Access Compliance Report

Public Rights-of-Way

(Pedestrian Signals)

Intersection ID: N/A	Main Street:	Cross Street: N/A	Location: N/A
ADA ID: 353AAC1027A3	Signal Type: Two Push Buttons-APS	Overall Compliance: No	Severity Score: BTN 1:N/A BTN 2: N/A No BTN: N/A
Codes/Mitigation Info/Possible Solution		Field Measurements/Component Compliance

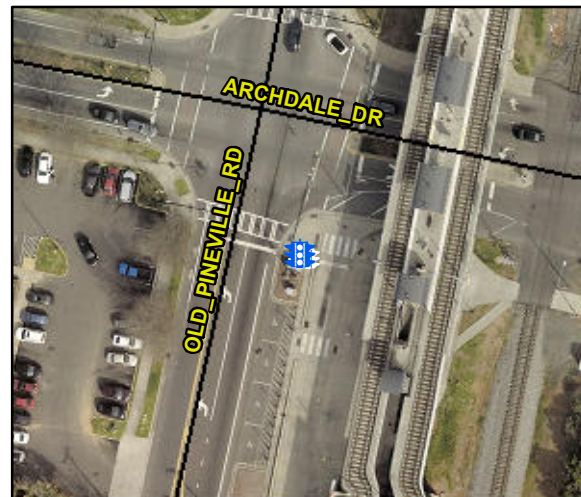
Surveyor Notes: 3 BUTTONS ON ONE POLE

Compliance	Description	Data	Compliance	Description	Data
	Button Count	Button2	No	Distant to Additional Button (in)	N/A
	Additional Button Present?	Yes		Additional Button ID	D93BAEA4AEF7
N/A	Signal Buttons Required?	N/A	N/A	Additional Ped Posts Required	N/A
	How Many Ped Street Xings?	3		Located In An Island/Median?	Yes
N/A	B 1 Sign Present?	Yes	N/A	B 2 Sign Present?	Yes
Yes	B 1 Sign Purpose?	Yes	Yes	B 2 Sign Purpose?	Yes
Yes	B 1 Sign Lettering & Contrast?	Yes	Yes	B 2 Sign Lettering & Contrast?	Yes
Yes	B 1 Parallel To XWalk?	Yes	Yes	B 2 Parallel To XWalk?	Yes
Yes	B 1 PAR to Button?	Yes	Yes	B 2 PAR to Button?	Yes
Yes	B 1 PAR to XWalk?	Yes	Yes	B 2 PAR to XWalk?	Yes
Yes	B 1 Clear Floor Space?	Yes	Yes	B 2 Clear Floor Space?	Yes
N/A	B 1 FWD Approach?	Yes	N/A	B 2 FWD Approach?	Yes
N/A	B 1 FWD Approach Constrained?	No	N/A	B 2 FWD Approach Constrained?	No
No	B 1 FWD Approach Reach (in)	19.0	No	B 2 FWD Approach Reach (in)	4.0

N/A	B 1 FWD Approach Width (in)	N/A	N/A	B 2 FWD Approach Width (in)	N/A
N/A	B 1 FWD Approach Obstruction?	Yes	N/A	B 2 FWD Approach Obstruction?	Yes
N/A	B 1 FWD Approach Obstruction Dist (in)	4.0	N/A	B 2 FWD Approach ObstructionDist (in)	2.0
N/A	B 1 PARA Approach?	Yes	N/A	B 2 PARA Approach?	Yes
N/A	B 1 PARA Approach Constrained?	No	N/A	B 2 PARA Approach Constrained?	No
Yes	B 1 PARA Approach Reach (in)	6.0	Yes	B 2 PARA Approach Reach (in)	4.0
N/A	B 1 PARA Approach Width (in)	N/A	N/A	B 2 PARA Approach Width (in)	N/A
N/A	B 1 PARA Approach Obstruction?	Yes	N/A	B 2 PARA Approach Obstruction?	Yes
N/A	B 1 PARA Approach Obstruction Dist (in)	2.0	N/A	B 2 PARA Approach ObstructionDist (in)	2.0
No	B 1 Clear Floor Space Slope (%)	3.3	No	B 2 Clear Floor Space Slope (%)	10.9
No	B 1 Clear Floor Space XSlope (%)	9.2	Yes	B 2 Clear Floor Space XSlope (%)	1.6
N/A	B 1 PAR Slope (%)	1.5	N/A	B 2 PAR Slope (%)	0.8
Yes	B 1 Height (in)	38.0	Yes	B 2 Height (in)	38.0

Yes	B 1 Clear Xing Direction?	ClearlyMarked	Yes	B 2 Clear Xing Direction?	ClearlyMarked
	B 1 Crossing Direction	To N		B 2 Crossing Direction	To W
Yes	B 1 DistanceTo XWalk (in)	0.0	Yes	B 2 DistanceTo XWalk (in)	0.0
No	B 1 DistanceTo Curb (in)	194.0	No	B 2 DistanceTo Curb (in)	87.0
Yes	B 1 Diameter (in)	2.0	Yes	B 2 Diameter (in)	2.0

Possible Solutions: Replace Signal Push Button With APS Button on New Post. Remove & Relocate Sign.
